Agenda Item # 9

MOD-003524-2025

- Modification of a previously approved Planned Unit Development

APPLICATION NUMBER	9	DATE	November 20, 2025
APPLICANT	Chris Lieb, Lieb Engineering Company, LLC		
REQUEST	PUD Modification

SITE PLAN

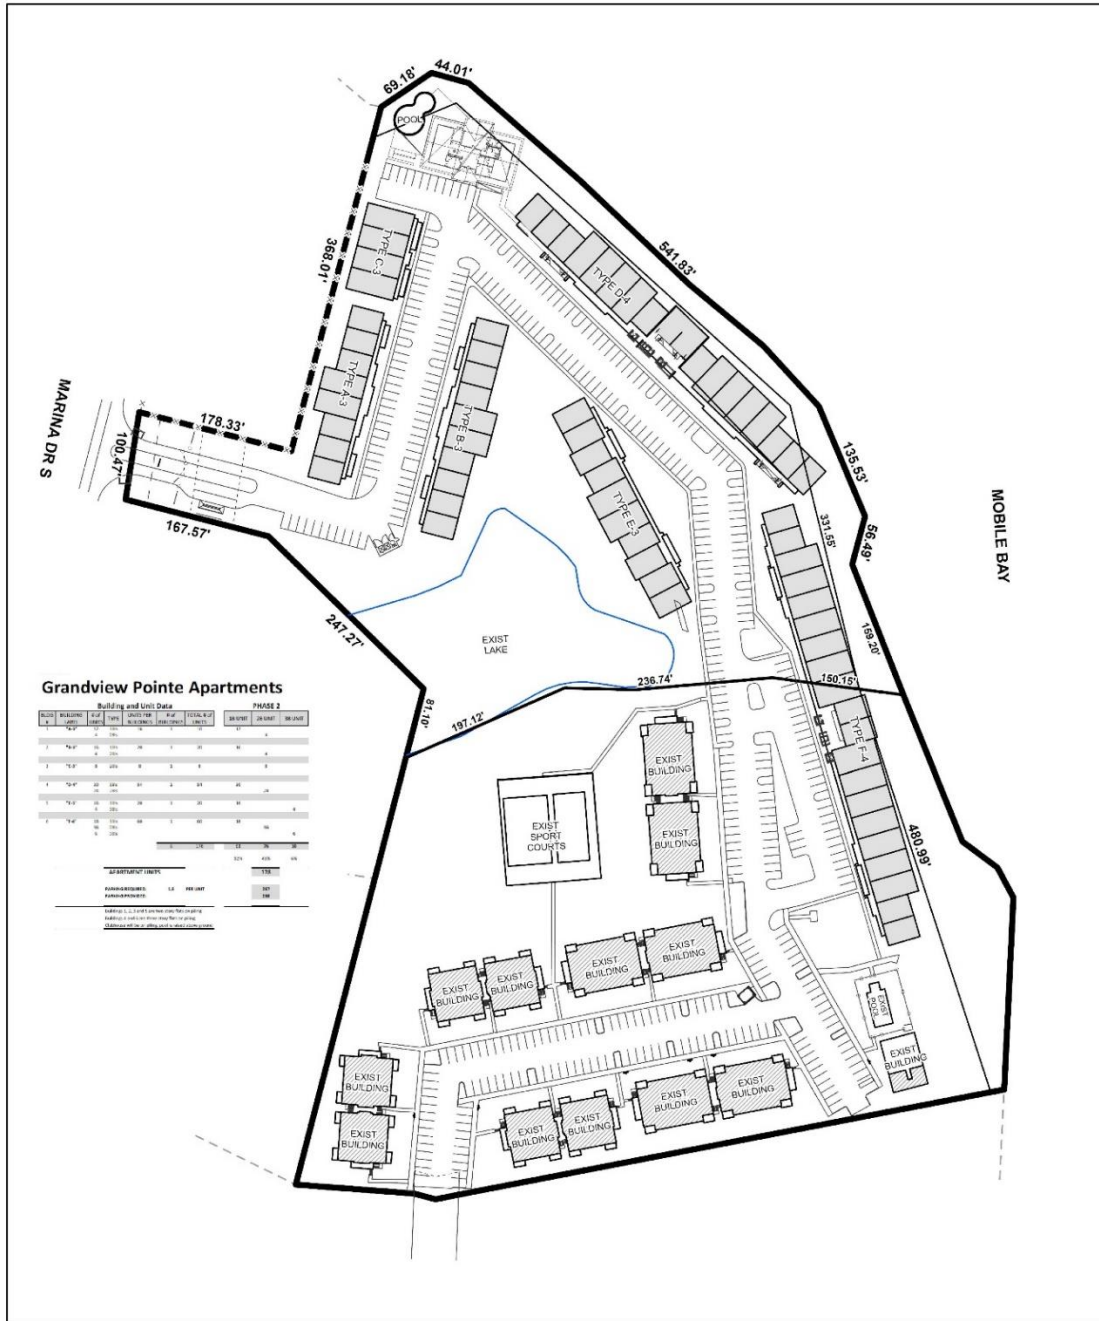
1. Revise the NAME and other information shown in the TITLE BLOCK that is wrong (i.e. LEIGHTON VILLAGE, TWILLEY BUILDERS, LLC.)
2. Retain NOTES #1 - #8, as shown on the Grandview Pointe Apartments PUD PLAN sheet 1 of 1 dated 3/29/2023.

The site plan depicts the existing and proposed structures on the site, but does not provide the number of units that are existing on the site currently, nor the total number of units proposed after the addition, making it difficult for staff to determine if there will be sufficient parking available on the site. The applicant should revise the site plan to provide both the number of existing and proposed units, as well as the number of parking spaces available.

Surrounding properties are located outside of the City of Mobile, in an unincorporated portion of Mobile County, with properties to the South being developed residentially and properties to the Southwest being vacant. As such, if approved, a residential buffer compliant with Section 64-3-8 of the UDC will be required, and should be shown on the site plan.

It should be noted that there is not an existing sidewalk along Marina Drive South. As the site is being redeveloped, the site will either need to provide a sidewalk, or submit a Sidewalk Waiver application to the Planning Commission for consideration. If a sidewalk is to be provided, a pedestrian walkway compliant with the requirements of Article 3, Section 64-3-3 of the UDC must be provided.

Bicycle parking is neither depicted nor addressed on the parking table. The site plan should be revised to comply with bicycle parking standards outlined in Article 3, Section 64-3-12.A.9. of the UDC, including minimum quantities and location requirements.

The size of both existing and proposed buildings should be labeled in square feet on a revised site plan or included in a table on the Final PUD Site Plan.

A dumpster is shown on the site plan with an enclosure on unknown materials and design. If approved, a note referencing compliance with dumpster enclosure and placement standards of Section 64-3-13.A.4. of the UDC should be added to the Final PUD Site Plan.

The application submitted does not include a legal description for the entire site, and will need to be revised, as the PUD pertains to both Lot 1 and Lot 2 of the Grandview Apartments Subdivision. Furthermore, the site plan states that it is for the “Leighton Village”, which is owned by “Twilley Builders, LLC”. As this appears to be information from an unrelated project, the site plan should be corrected.

1. Revision of the site plan to include the number of dwelling units, both existing and proposed;
2. Revision of the site plan to include the number of parking spaces, both existing and proposed;

3. Revision of the site plan to include depiction of a sidewalk along Marina Drive South;
4. Revision of the site plan to illustrate compliance with the pedestrian walkway requirements of Article 3, Section 64-3-3 of the UDC;

5. Revision of the site plan to depict a residential buffer compliant with Section 64-3-8 of the UDC;
6. Revision of the site plan to either depict bicycle parking spaces or placement of a note stating that the site will provide bicycle parking in compliance with Article 3, Section 64-3-12.A.9. of the UDC;

8. Revision of the site plan to label the size of each building in square feet or provide a corresponding table with the same information;
9. Provision of building elevation drawings demonstrating compliance with Article 3, Section 64-3-6 of the UDC, or placement of a note on the revised site plan stating that each new building will comply with these standards;

12. Revision of the site plan to include the correct project name and property owner;
13. Revision of the legal description to include both Lot 1 and Lot 2 of the Grandview Apartments Subdivision;
